MONTGOMERY COUNTY PLANNING DEPARTMENT
THE MARYLAND-NATIONAL CAPITAL PARK AND PLANNING COMMISSION

REVIEW TYPE: Preliminary Plan of Subdivision

PROJECT NAME: Calco Fence
CASE #: 120070040
REVIEW BASIS: Chapter 50, Montgomery County Subdivision Regulations

ZONE: I-1
LOCATION: 18101 Sellman Road, 500 feet southeast of Beallsville Road
MASTER PLAN: Preservation of Agriculture and Rural Open Space

Figure 2: Preliminary Plan

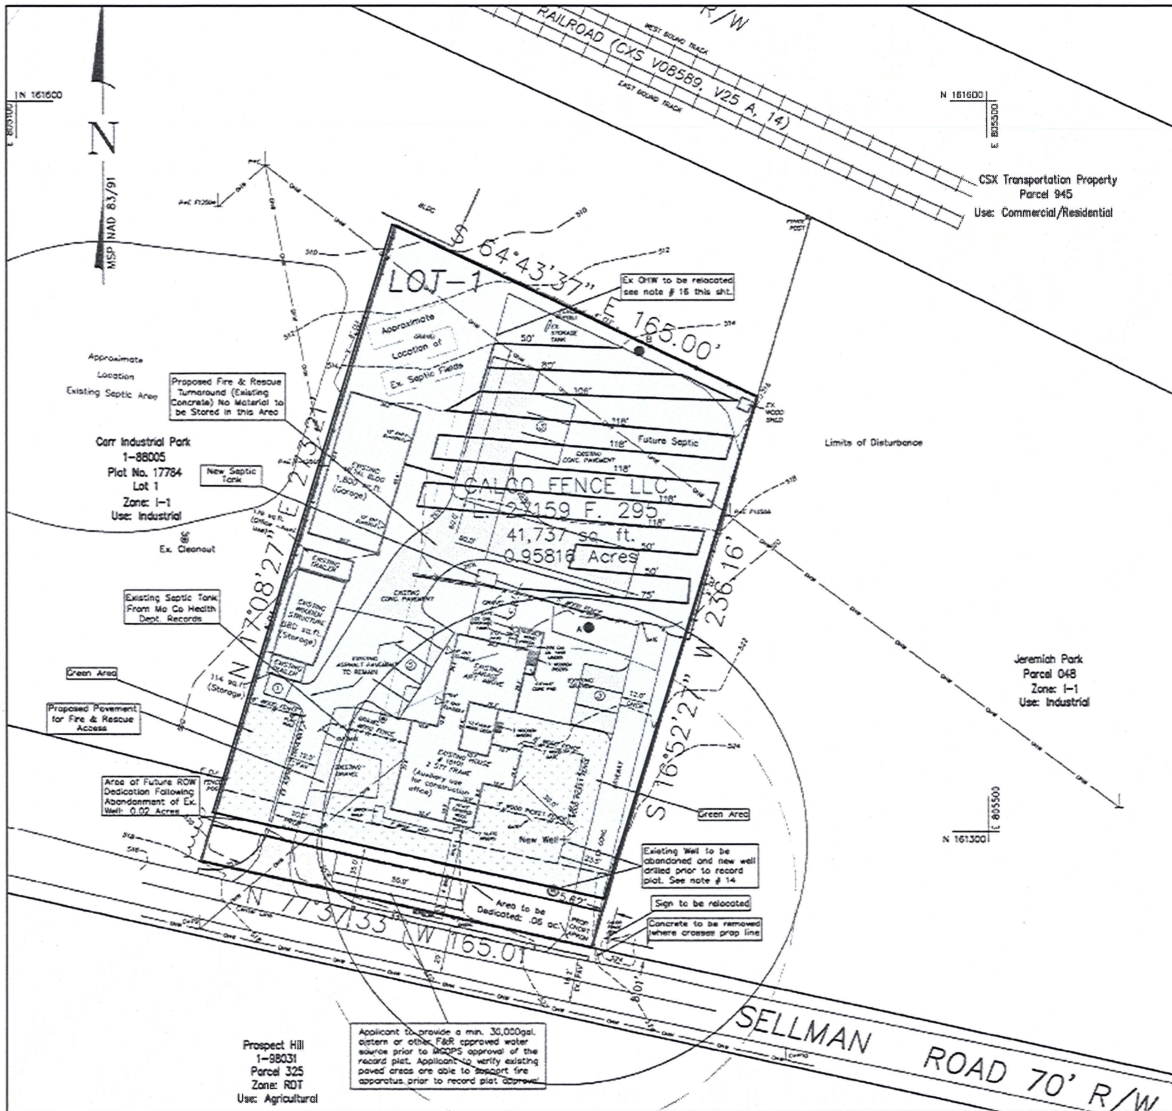
1. Show/label all existing planimetric and topographic details specifically paving (width does not match the label), storm drainage, driveways adjacent and opposite the site on the preliminary plan.

2. Dedicate right of way for Sellman Road as necessary and improve it to country road standards.
3. Grant necessary slope and drainage easements. Slope easements are to be determined by study or set at the building restriction line.

4. Wells and septic systems cannot be located within the right of way nor slope or drainage easements.
5. Perform the necessary adjustments so driveway aprons do not cross the property lines.

10. The sight distances study has not been accepted. Prior to approval of the record plat by DPS, the applicant's engineer will need to submit a revised sight distances certification. The revised form will need to reflect the updated sight distance when tree trimming and/or removal has been completed to achieve a minimum of three hundred and twenty five (325) feet of sight distance in each direction.

12. For safe simultaneous movement of vehicles, we recommend a driveway pavement width of no less than twenty four (24) feet to allow vehicles to enter and exit the site without encroaching on the opposing lanes. This pavement width will permit an inbound lane width of fourteen (14) feet and an exit lane width of ten (10) feet.
